City of
Peterborough

Committee of Adjustment

Hearing Date: December 2, 2020

Staff Recommendations Regarding Files: B09/20, B10/20, B11/20, A26/20, and A27/20

Exhibit B, Page 1 of 1

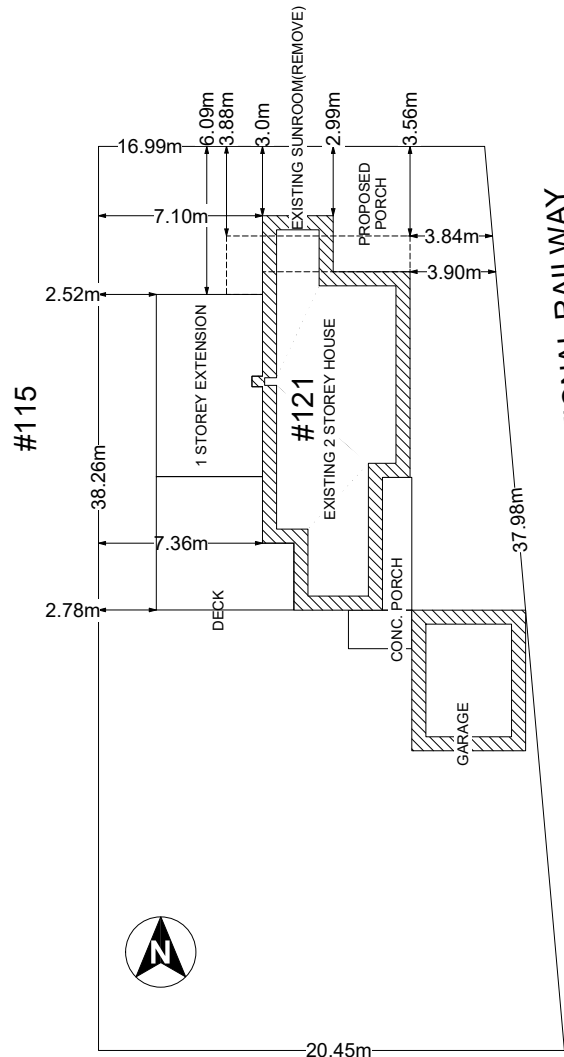
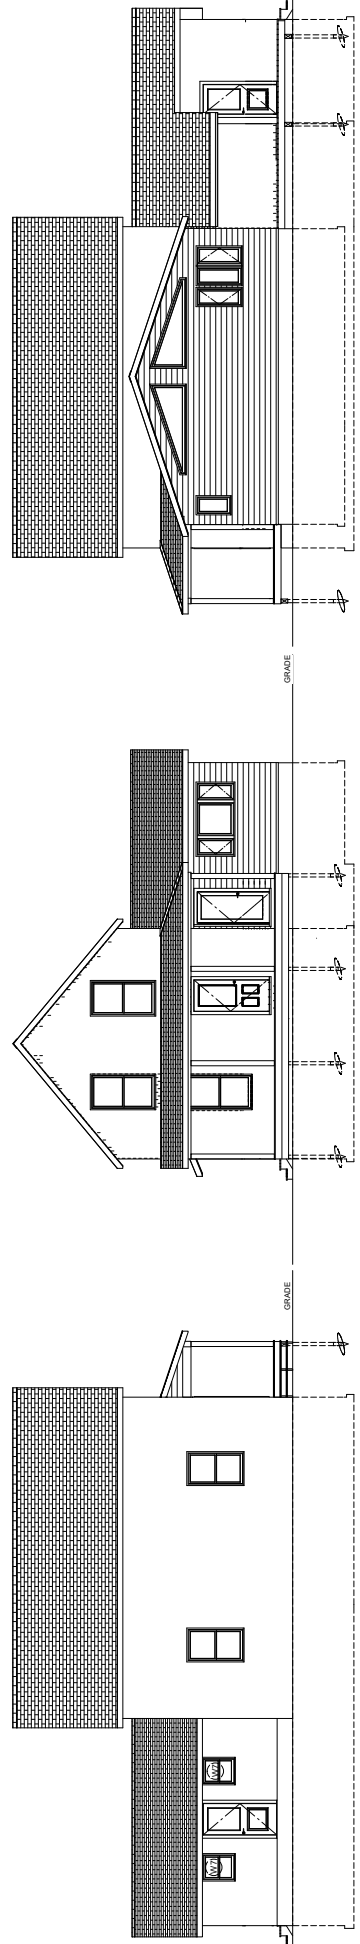
Peterborough Distribution reviewed the application and identified that the overhead electrical service to the property needs to be repaired and clearances to the proposed porch be maintained.

Peterborough Utilities Commission (PUC) reviewed the application and notes that the proposed front porch is in close proximity to the existing water service and curb stop. Locates are to be completed prior to construction.

Staff recommends that the Committee of Adjustment **approve** the application provided that construction related to this approval proceed substantially in accordance with the concept plan attached as Exhibit B and conditional upon the applicant obtaining written approval from PDI regarding the porch clearance from the overhead lines and completing the locates for the water service and curb stop.

#1120 RIPPINGALE TR.
REG. PLAN NO. 45M-254
CITY OF PETERBOROUGH

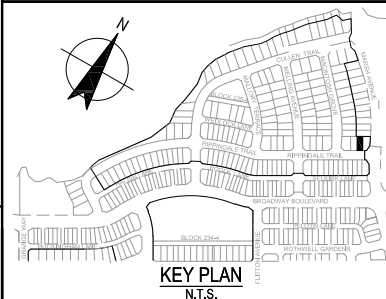
To facilitate the construction of the proposed single-detached dwelling on the subject property, the applicant has requested a minor variance from Section 359.3(e)(ii) of the SP.329 zoning district to reduce the minimum building setback from a rear lot line from 6.0 metres to 5.6 metres (Exhibit C). Staff has reviewed the concept plan submitted in support of the application and is of the opinion that the requested variance is minor in nature and represents a desirable and appropriate use of the land.

Staff recommends that the Committee of Adjustment **approve** the application provided that construction related to this approval proceed substantially in accordance with the concept plan attached as Exhibit C.
